TAYLORCRAFT AVIATION CORP. . SB No. 78-002, Sept. 19, 1978

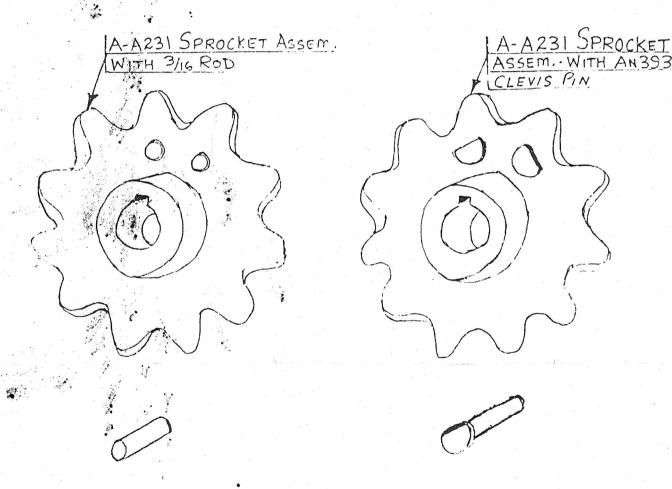
If any of (a), (b) or (c) are found unsatisfactory, replace the sprocket within the next ten (10) hours or by Dec. 1, 1978. If above are found satisfactory, new sprocket must be installed within next fifty (50) hours in time in flight or by May 1, 1979. Until then reinspect per this bulletin every ten (10) hours.

3/16 ROD AS STOPS
LINSATISFACTORY

AN 393 CLEVIS PIN AS STOPS

SATISFACTORY

- (3) New sprocket assembly, TAC P/N A-A231 may be obtained from the factory as follows:
 - (a) New sprocket will be shipped upon receipt of unsatisfactory sprocket from customer.
 - (b) New sprocket may be purchased at \$7.00 plus tax if applicable. Refund will be made upon receipt of unsatisfactory sprocket.
 - (c) Aircraft which are within warranty period will be compensated for labor at \$12.00 per hour, maximum time allowed two (2) hours.
